[1] REDLINE REVISION 1/4/06

(A) SHA# AT7185185 8/25/05
RECONSTRUCT REVERSIBLE LANE SYSTEM TO MAST ARM
JWA KMP JAH MAR DAZ TH

MD 97 (GEORGIA AVE) FROM I-495 TO LUZERNE AVE (REVERSIBLE LANE SYSTEM)

TS NO. 203A DRAWING NO. 4 OF 5 SHEET NO. OF

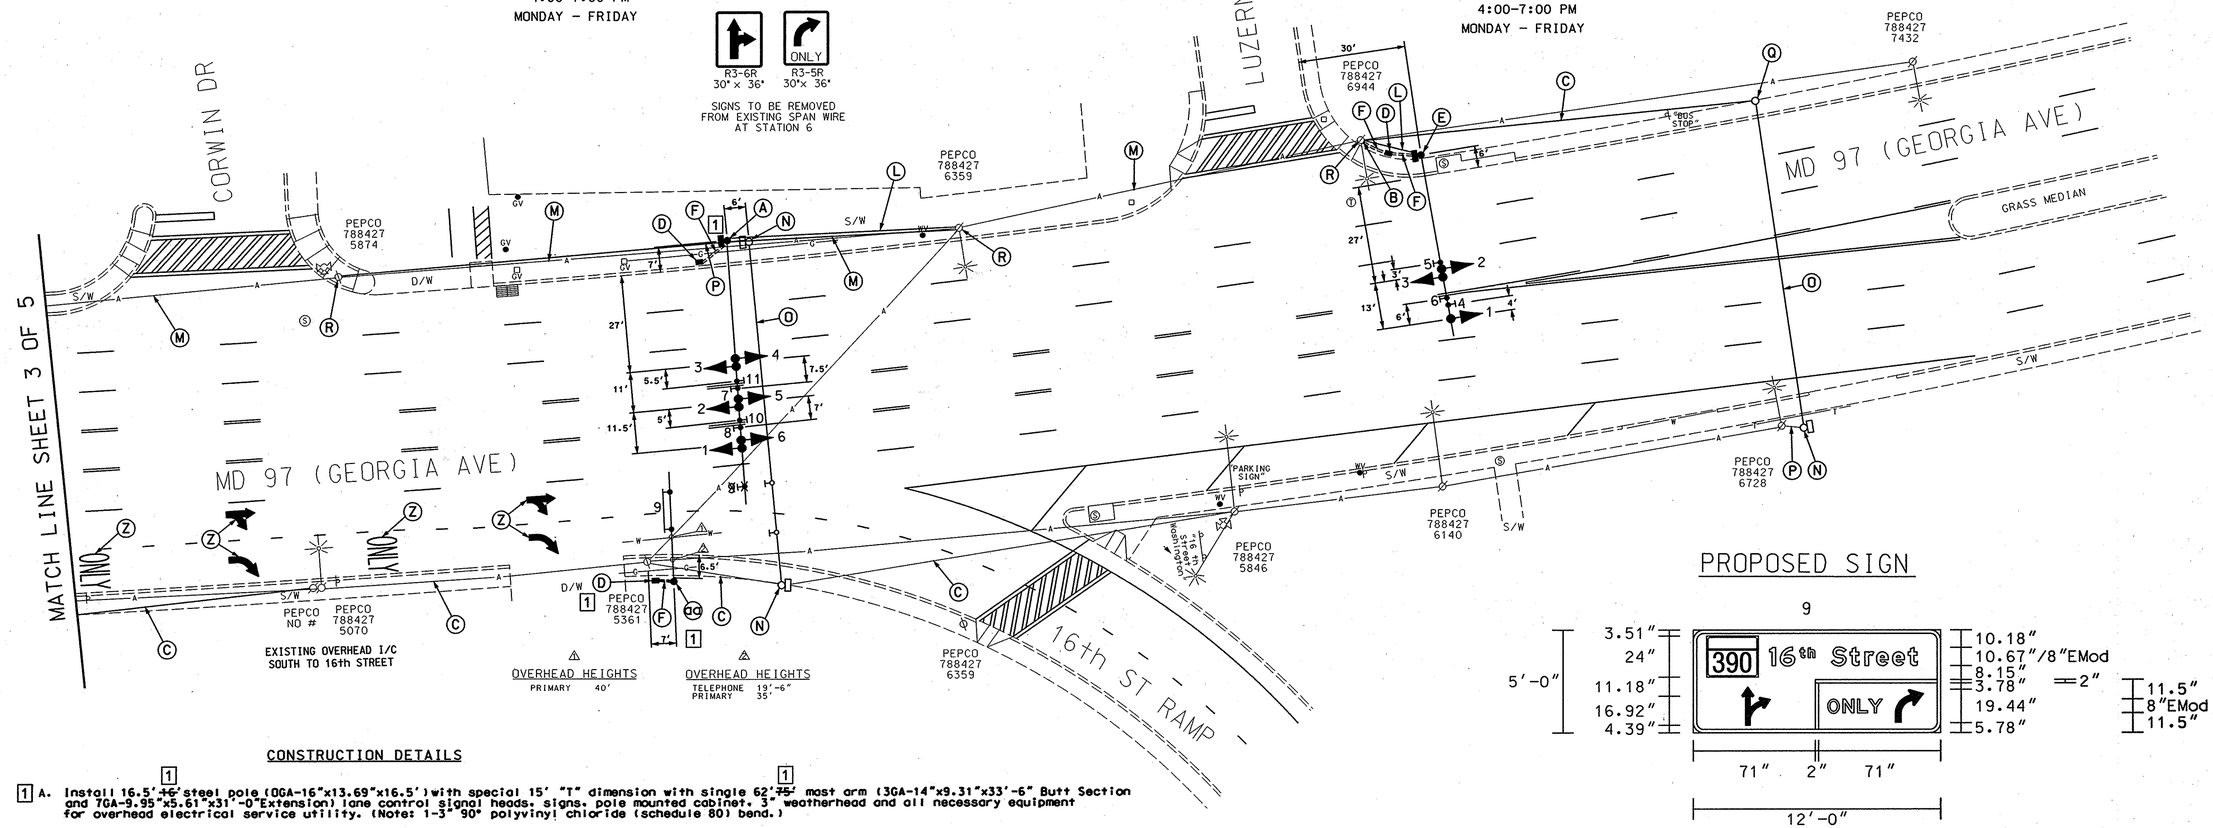
9 — R3-8 ONLY — ~~60" x 36"~~

[1] A. Install 16.5' ~~16'~~ [1] steel pole (OGA-16"x13.69"x16.5') with special 15' "T" dimension with single 62' ~~75'~~ [1] mast arm (3GA-14"x9.31"x33'-6" Butt Section and 7GA-9.95"x5.61"x31'-0"Extension) lane control signal heads, signs, pole mounted cabinet, 3" weatherhead and all necessary equipment for overhead electrical service utility. (Note: 1-3" 90° polyvinyl chloride (schedule 80) bend.)

[1] aa. Install 16' steel pole with special 15' "T" dimension with single 60' mast arm (cut to 30') and sign. (Note: 1-3" 90° polyvinyl chloride (schedule 80) bend.)
